FIELD CHANGE ORDER — Service

Issued by	:	PMS DMC Hamburg	**FCO Ref. No.**	:	FCO70400026
Supersedes	:	4512 980 64301 REV AA	**Date**	:	March 2008
Publication No.	:	**4512 980 64301 REV AB**	**Revision**	:	B

BuckyDiagnost

TITLE: GENERATOR MAINS CIRCUIT MODIFICATION ENK3

Removal of ENK3

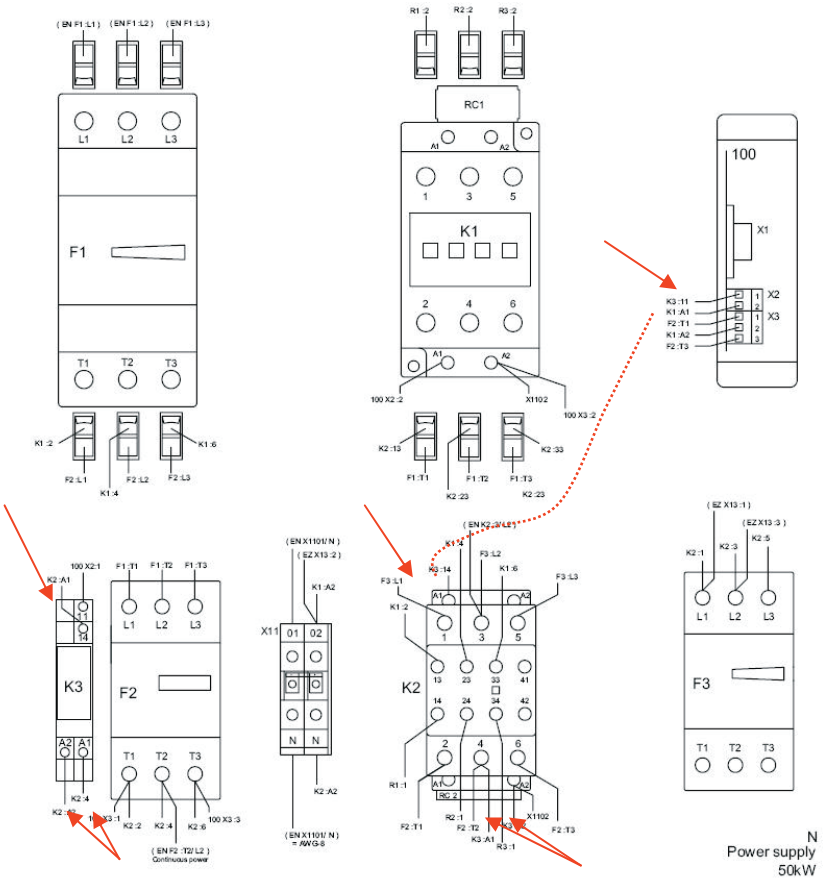
Symptom	:	ENK3 gets damaged shortly after power on in case the system is connected to a single-side grounded mains supply
		DMC00001863
Cause	:	The relay is connected to 400V instead of 230V
Remedy	:	Removal of phase supervision relay ENK3

- **Shut down the incoming power and follow proper lockout procedures.**
- Switch the generator off.
- Open the cabinet.
- Switch ENF1 off.
- Disconnect the wire from ENK3:11.
- Remove the wire from ENK3:14 – ENK2:A1.
- Connect the wire from **EN100:X2:1** to ENK2:A1.
- Remove the wire from ENK3:A1 – ENK2:4.
- Remove the wire from ENK3:A2 – ENK2:A2.
- Remove the relay ENK3 from the generator.
- Switch ENF1 on.

- Close the cabinet.
- Switch the generator on.
- Check all applicable functions.
